## DEFECTS REPORT

TINKERS LANE SURGERY  
ROYAL WOOTTON BASSETT  
SWINDON  
SN4 7AT

REFERENCE: HW958  
DATED: MARCH 2026

*Image 12: Waiting Room Glass Temperature (External).*

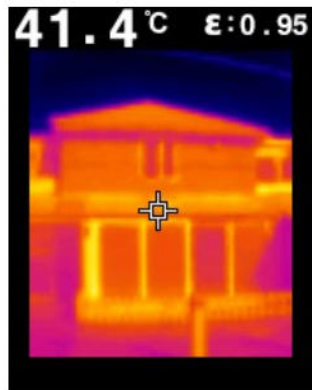
Using a thermal imaging camera for comparative assessment, the surface temperature of the glazing within the consultation room was recorded at approximately 60°C at the time of inspection. It should be noted that the external ambient temperature on the day was approximately 13°C, and therefore glazing temperatures are likely to increase significantly during warmer periods and under stronger solar exposure.

With the installation of insulation and a plasterboard ceiling beneath the roof glazing in the waiting room, the opportunity for heat to dissipate from beneath the glazing has been substantially reduced. As a result, heat is likely to accumulate within the void between the glazing and the ceiling, meaning the glazing within the waiting room is likely to be exposed to considerably higher temperatures during periods of solar gain.
